DART SERVICE INSTRUCTION

TO AMEND INSTALLATION INSTRUCTIONS IIN-D205-594 Rev. C (AND EARLIER) AND
INSTRUCTIONS FOR CONTINUED AIRWORTHINESS ICA-D205-594 Rev. 2 (AND EARLIER)
REF. CANADIAN STC: SH03-6
REF. FAA STC: SR01742NY

DESIGN		DART AEROSPACE LTD	
DRAWN		HAWKESBURY, ONTARIO, CANADA	
CHECKED	<u>PH</u>	DRAWING NO.	REV. B
MFG. APPR.	<u>BE</u>	DSI 9396	SHEET 2 OF 2
APPROVED	<u>NO</u>	TITLE	SCALE
DE APPR.	<u>CH</u>	CROSSTUBE SUPPORT CHANGE	NTS
DATE	07.12.04	COPYRIGHT © 2007 BY DART AEROSPACE LTD THIS DOCUMENT IS PRIVATE AND CONFIDENTIAL AND IS SUPPLIED ON THE EXPRESS CONDITION THAT IT IS NOT TO BE USED FOR ANY PURPOSE OR COPIED OR COMMUNICATED TO ANY OTHER PERSON WITHOUT WRITTEN PERMISSION FROM DART AEROSPACE LTD.

FIGURE 1: INSTALLATION OF SUPPORT ON CROSSTUBE

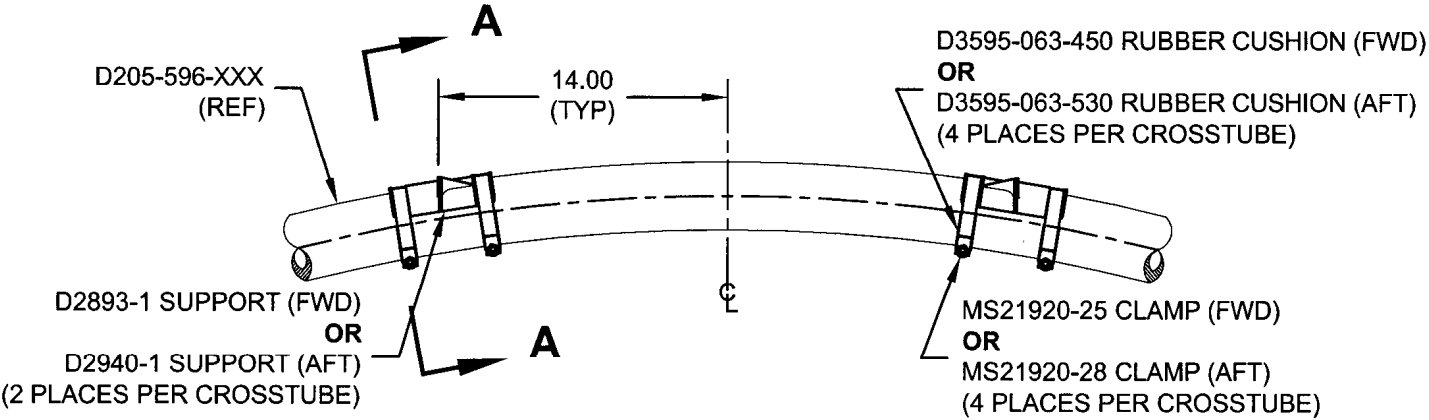
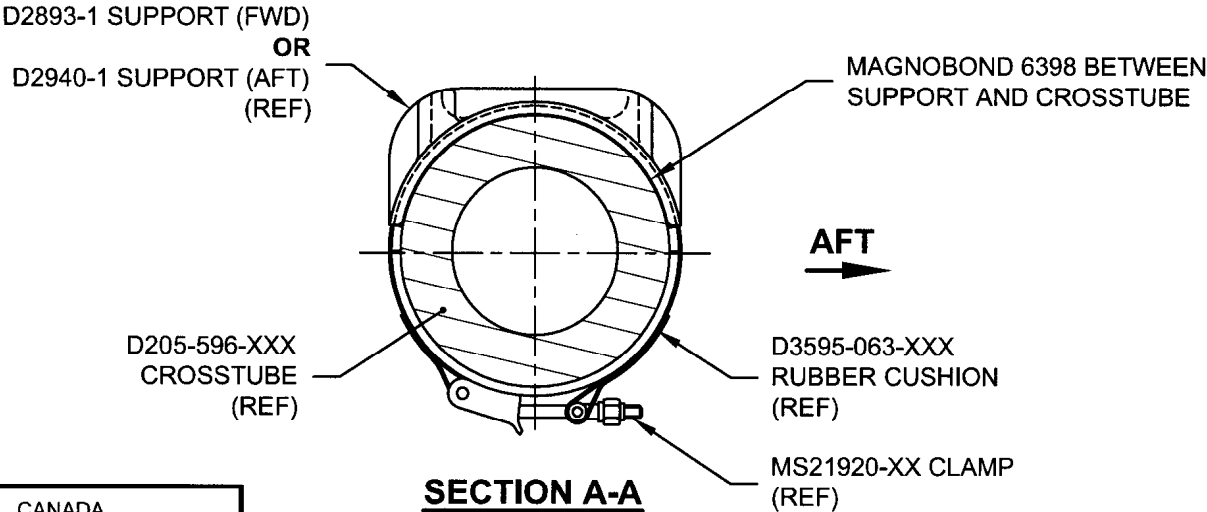
To prevent the supports from shifting on D205-596-101/-103/-105/-107 Crosstubes at CHG 001, the D2893-1 or D2940-1 Supports should be removed and re-installed as follows:

- Apply a 0.03" to 0.06" thick layer of Magnobond 6398 underneath D2893-1 or D2940-1 Supports and re-install the Supports on the crosstube as shown in Figure 1. Install a D3595-063-450/-530 Rubber Cushion on each MS21920-25/-28 Clamp. Position and secure the D2893-1 or D2940-1 Supports on the crosstube using MS21920-25/-28 Clamps. Torque clamps to 80-100 in·lb. Let the D205-596-101/-103/-105/-107 Crosstube Assembly cure before re-installing the crosstube on the aircraft.

Note: It is acceptable to substitute the MS21920-25/-28 with longer or shorter clamps to accommodate varying diameters. Ensure there is a minimum of 1.5 threads in safety on the nut.
